**DEVELOPMENT REVIEW COMMITTEE  
STAFF REPORT  
FEBRUARY 13, 2024**

**Application Number:** 23PLN-41  
**Subject:** Development Review Permit for the construction of a ±4,300 square foot retail paint store for Sherwin-Williams on a ± 1.5 acre parcel (after pending lot line adjustment) on Nevada City Highway (next to Lumberjacks Restaurant)  
**Owner:** Matt McWhirter (representative)  
**Applicant:** McWhirter Realty Partners  
**Zoning/General Plan:** Central Business (C-2) Zone/Commercial  
**Entitlements:** Development Review Permit

**Sherman Williams Retail Paint**  
**Development Review and Lot Line Adjustment**

SCHEMATIC ELEVATIONS - 1/31/2024  
 △ -  
 △ -  
 △ -  
 △ -  
 △ -  
 △ -

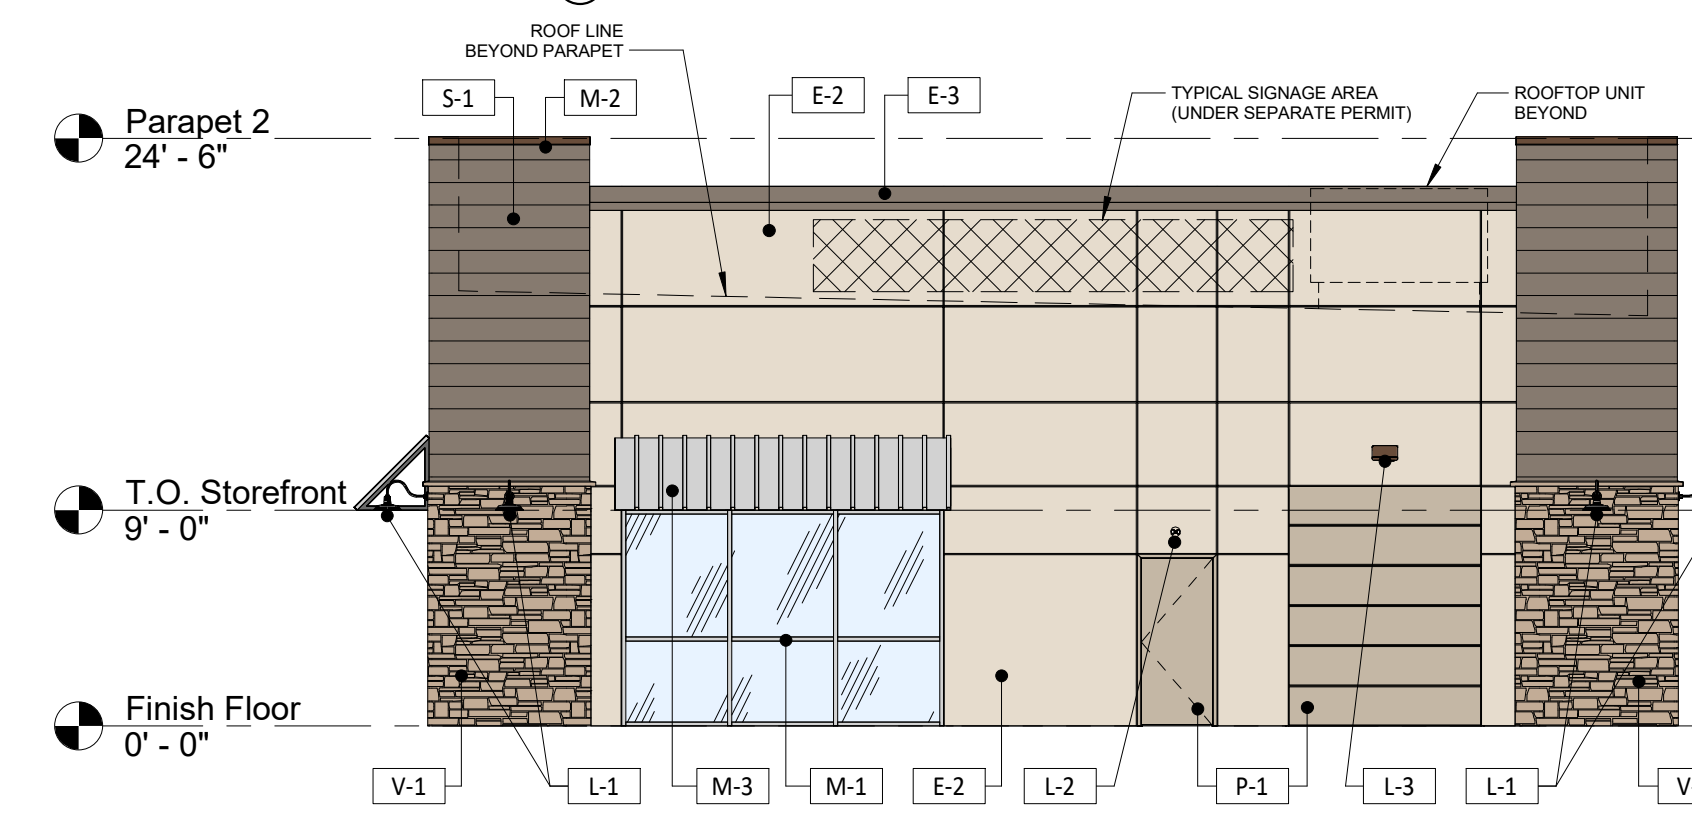
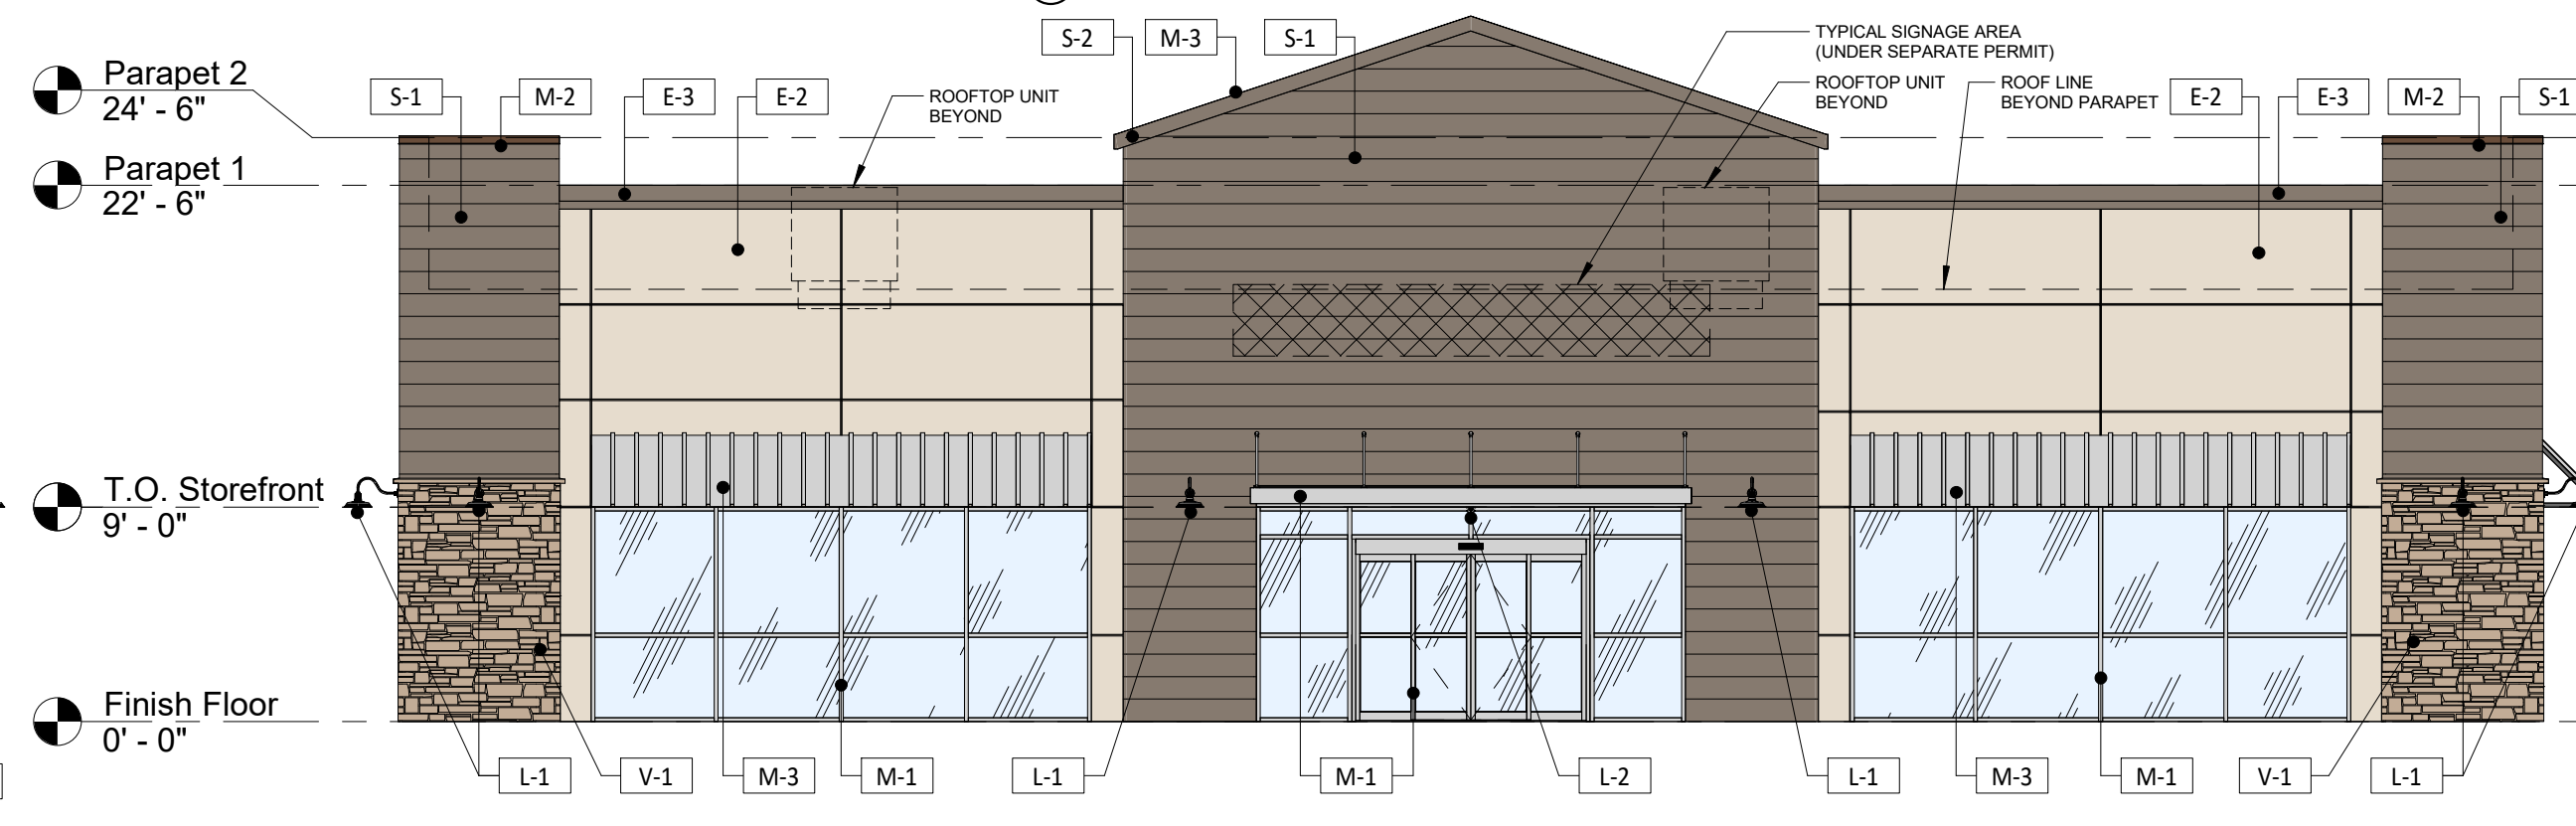
10. The applicant shall file for a sign permit prior to erecting signage.
11. The security lighting labeled on the light schedule as "L-2," and referenced on the east and south elevations will need to be revised to comply with the city's outdoor lighting standards in section 17.30.060 of the city municipal code.
